Proposed Project for Application to the Kansas Department of Health and Environment for the Kansas Public Water Supply Loan Fund

Applicant: City of Manhattan
Water Supply Treatment Plant and Wellfield Improvements Project

Agency Review Comments:

Re: City of Manhattan Kansas Public Water Supply Loan Fund Project No. 2462 -
Environmental Review

Project Title: Public Water Supply Loan Fund Application

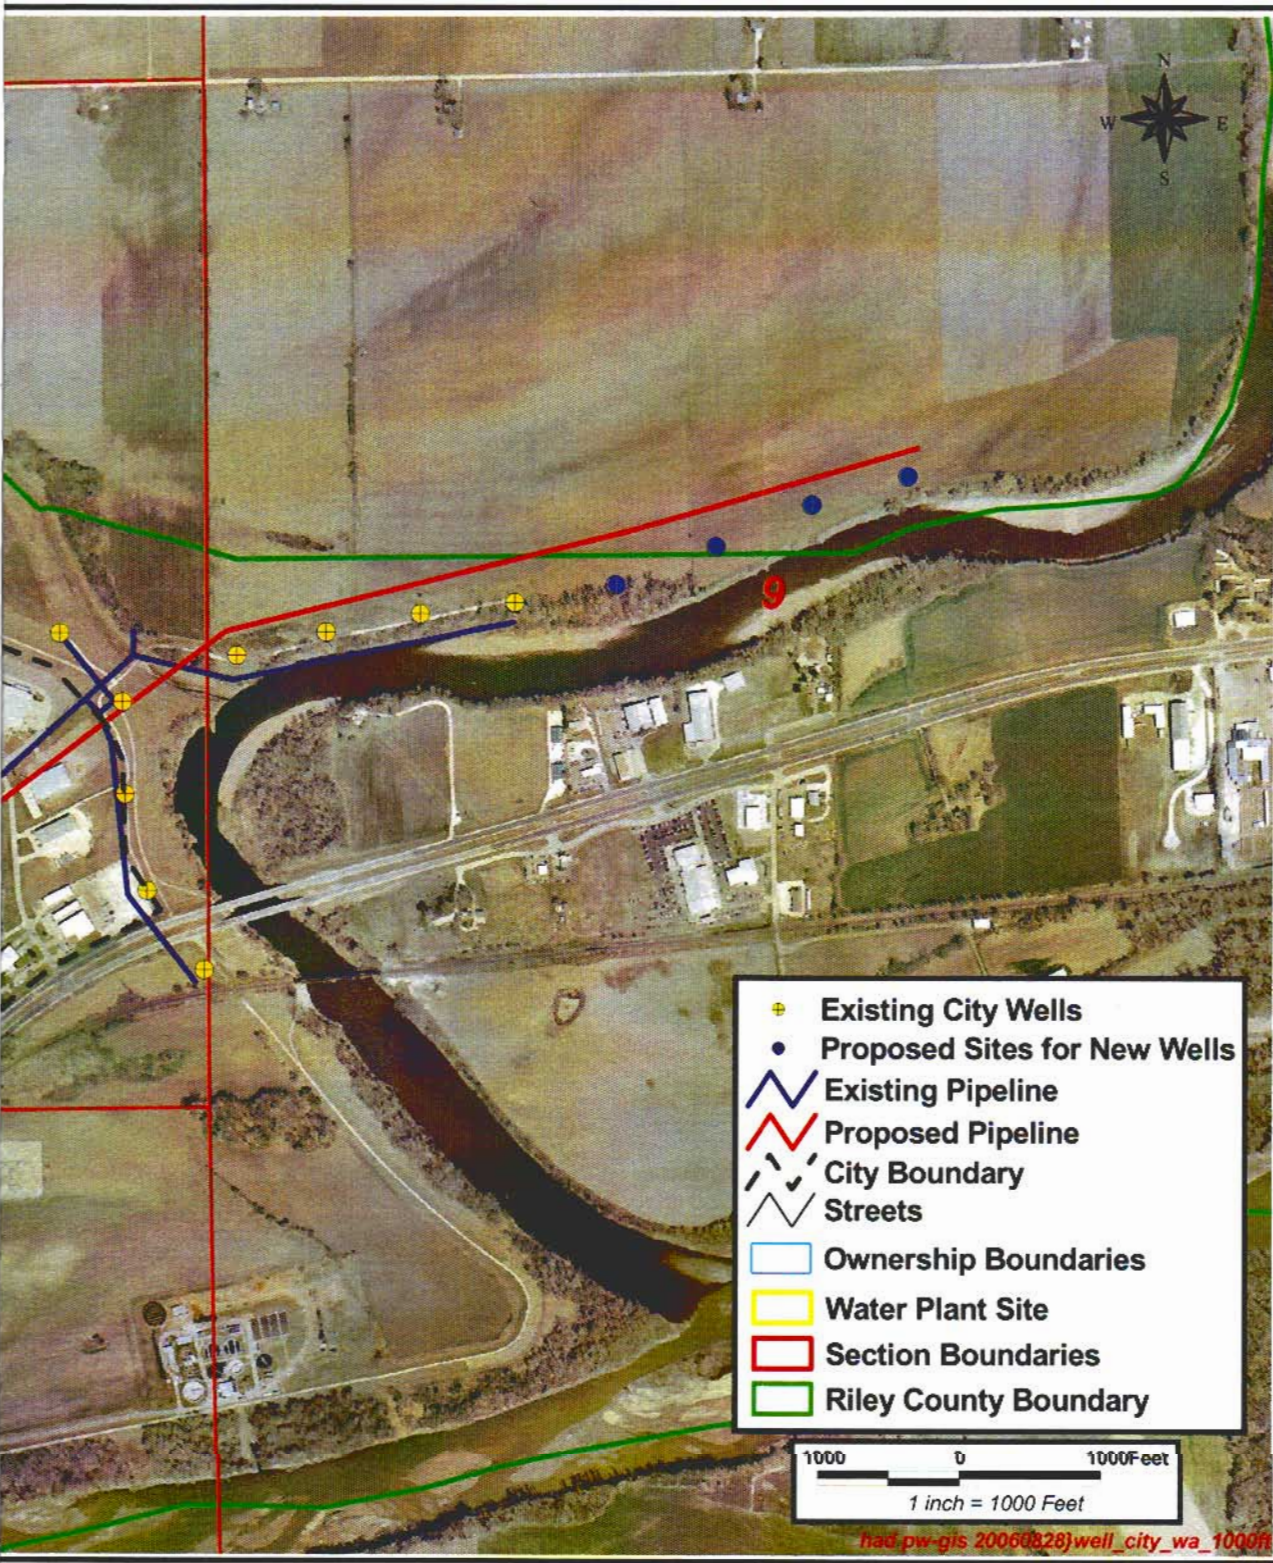
One of the reasons stated for constructing new water-supply wells as a part of the wellfield improvements is to retire old wells for which it is more costly to treat the raw water due to higher hardness values. The map showing the location of the old and new wells suggests that the new wells are expected to produce water with lower hardness (and lower total dissolved solids) due to being close to the river. Wells located close to the river would be expected to draw a greater proportion of their water from the river than wells farther away from the river. The wells farther from the Big Blue River could be expected to draw in more ground water that had flowed through the Permian shale and carbonate rocks, water which would be expected to be in equilibrium with calcite (and possibly dolomite) at a higher carbon dioxide pressure than atmospheric and, thus, which can hold in solution more calcium and magnesium than the river water, which would be in equilibrium with the atmospheric pressure of carbon dioxide. In addition, some of the Permian strata in the Manhattan area contains a small amount of gypsum (calcium sulfate) which has a higher solubility than calcite. This increases the calcium (a component of hardness) as well as sulfate. The sulfate also complexes with calcium and magnesium and increases the ionic strength of the ground water, which further increases the amount of dissolved calcium and magnesium that the water can hold.

Thus, the wells that would be expected to have the highest hardness would be expected to be located at the greatest distance from the river along flow paths of ground water discharge to the river. These would be the seven wells farthest to the west on the west side of the river. The nine wells currently located on the west side of the river appear to be close enough to the river that there may not be a significant difference between the hardness of the water pumped from them in comparison with the hardness of water from the proposed new wells. However, the fact that there is probably a component of ground-water flow through the alluvial aquifer in the general downstream direction (to the south-southeast) and that the river meanders of the river channel occupy a band to the east of the western boundary of the alluvial aquifer, suggests that the four most easterly existing wells and the four proposed new wells might intercept ground water with a slightly higher river-water component during pumping than the more westerly wells along the river.

Another factor is the distance of the bottom of the screened interval of the wells above the bedrock surface and the lithology of the sediments near the bottom of the aquifer as well as at the top of the aquifer below the river channel. Bedrock strata with a good hydraulic connection to the bottom of the aquifer would allow more ground water from the Permian rocks to enter a well than if there were a poor hydraulic connection and a layer of clay at the bottom of the aquifer. Likewise, the thickness and hydraulic conductivity of low permeability sediments at the top of the alluvial aquifer and below the river channel can affect the rate at which river water would be drawn in by the pumping wells. In general, the longer (more continuous) a well near the river is pumping, the greater the proportion of river water that would be drawn in. Thus, if the hardness of the well water is an important concern, a strategy of pumping a smaller number of wells near the river than a larger number of wells spread across a greater distance might be considered for increasing the amount of river water drawn in.

Although the hardness would be lower for a greater amount of river water drawn in by the pumping wells, the City may also wish to examine the amount of atrazine in the well water obtained from wells near the river during spring runoff events. Atrazine levels during spring runoff events are often high in Kansas. The City could determine whether the fine-grained sediments generally present in the shallower parts of the aquifer are enough to adsorb most of the atrazine.
